APPLICATION FOR APPROVAL TO USE AN EXISTING
ON-SITE WASTEWATER TREATMENT & DISPOSAL SYSTEM / WATER SUPPLY WELL

File # 4629B
Date _____

Street Address: 7804 Arlington Ch Tax Parcel #: 13928135

PROPOSED PLOT PLAN

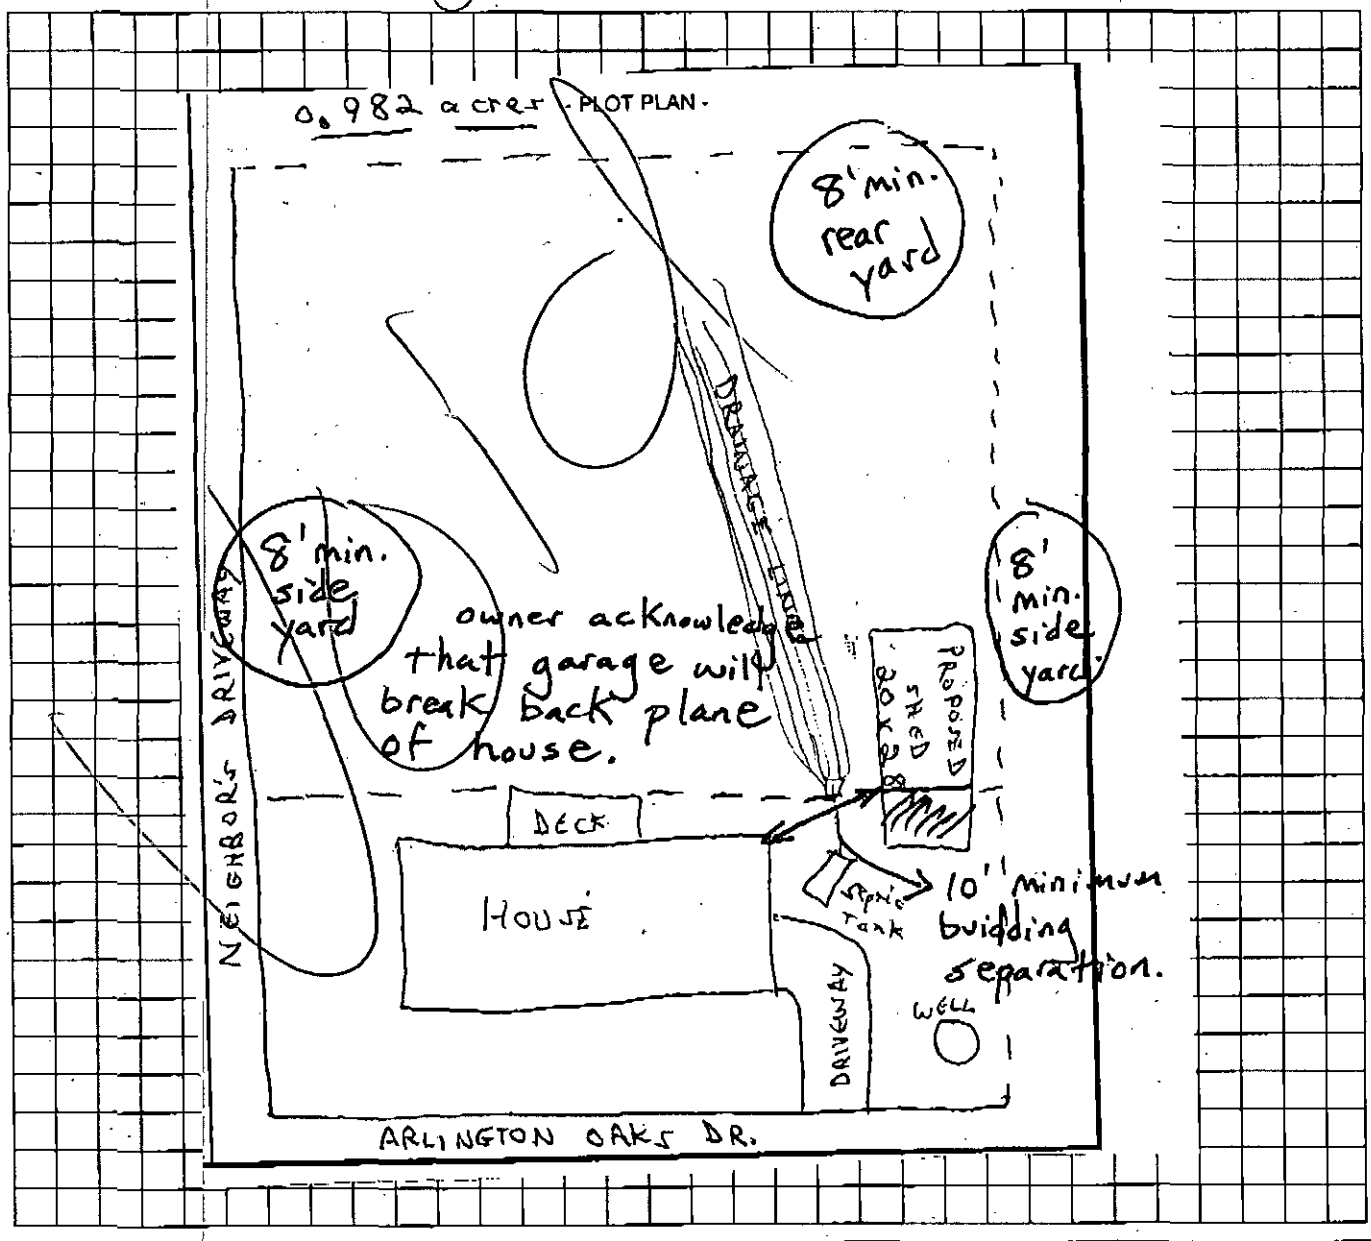
New plot plan submitted to meet required setback off septic system

ARLINGTON OAKS SUBDIVISION
LOT #13

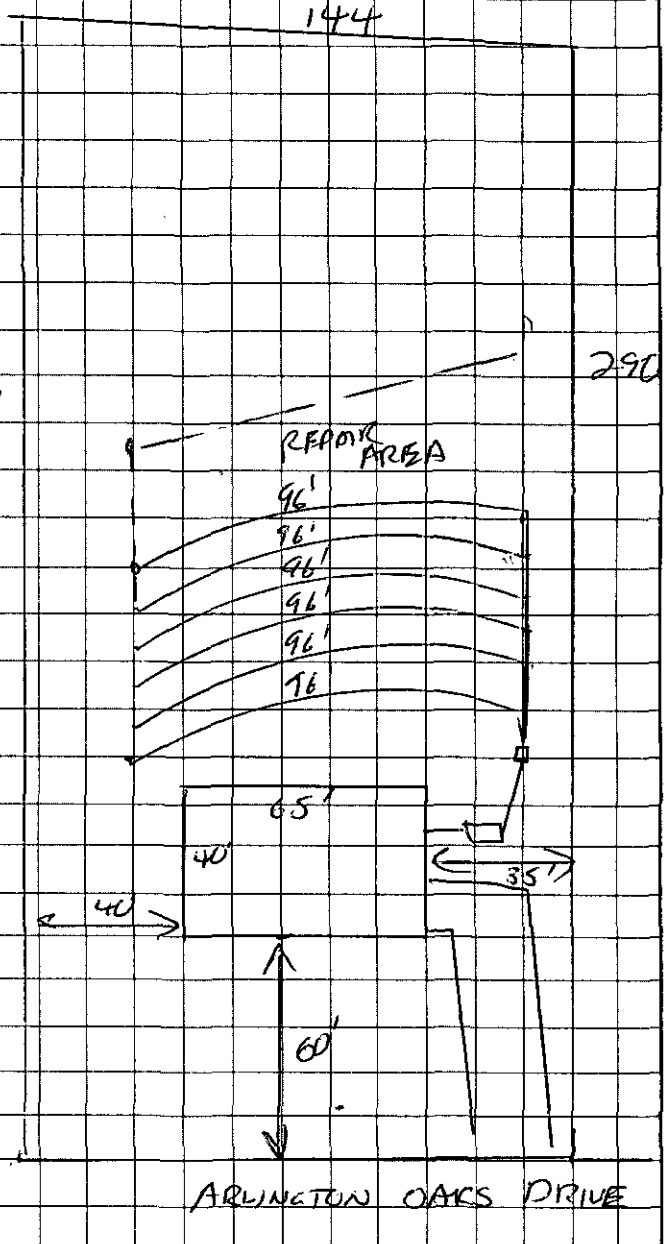
(1) LOCATE ALL WELLS 100' FROM ALL PARTS OF SEPTIC TANK SYSTEMS.

(2) INSTALL DRAINLINES SHALLOW (30") AND ON CONTOUR.

(3) ANY CHANGES TO THIS PLOT PLAN REGARDING HOUSE SIZE, LOCATION, OR DRAINFIELD LOCATION, ETC. WILL REQUIRE AND ADDITIONAL FEE AND SITE VISIT.

PLOT OF SYSTEM

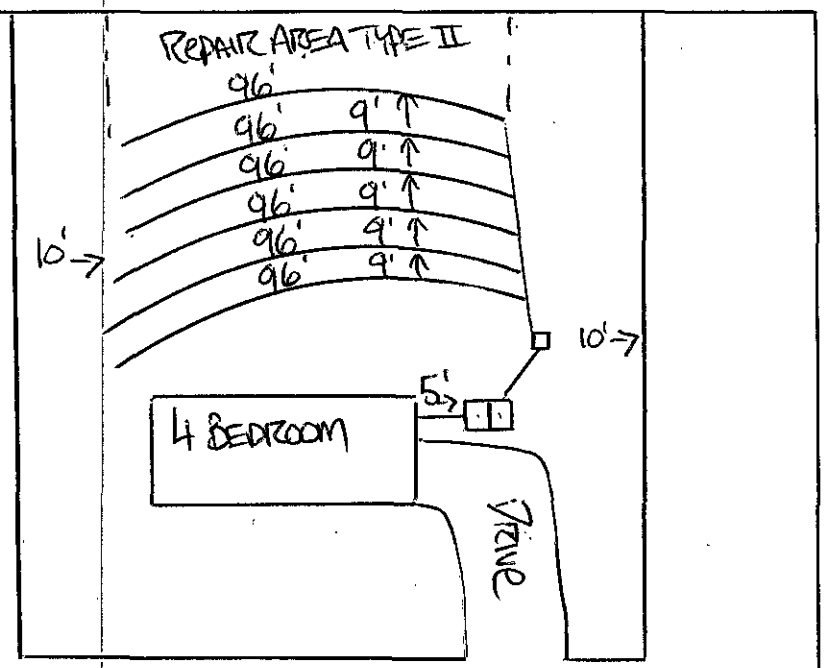
Comments: CONVENTIONAL TYPE II SYSTEM. INSTALL 6 LINES @ 96', 1500 ST INSTALL LINES ON CONTOUR, LEVEL & ON 9' CENTERS. STAY 750' FROM EXISTING WELL, 75' FROM HOUSE, 710' FROM PROPERTY LINE.

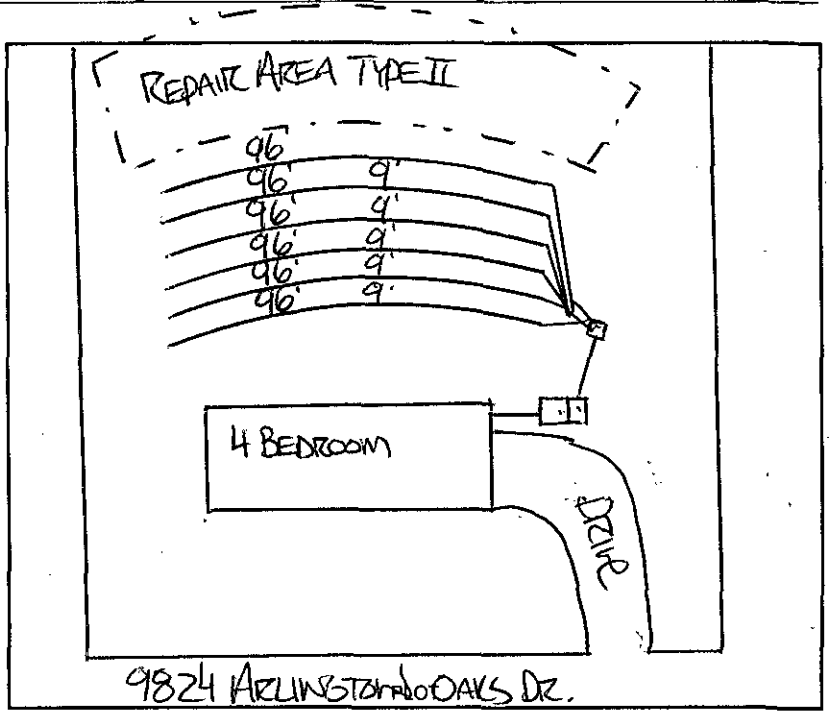
COMMENTS: TYPE II CONVENTIONAL; 6 LINES @ 96', 1500ST, TYPE II REPAIR. 710' FROM PROPERTY LINES, 75' FROM HOUSE FOUNDATION, 750' FROM WELL.
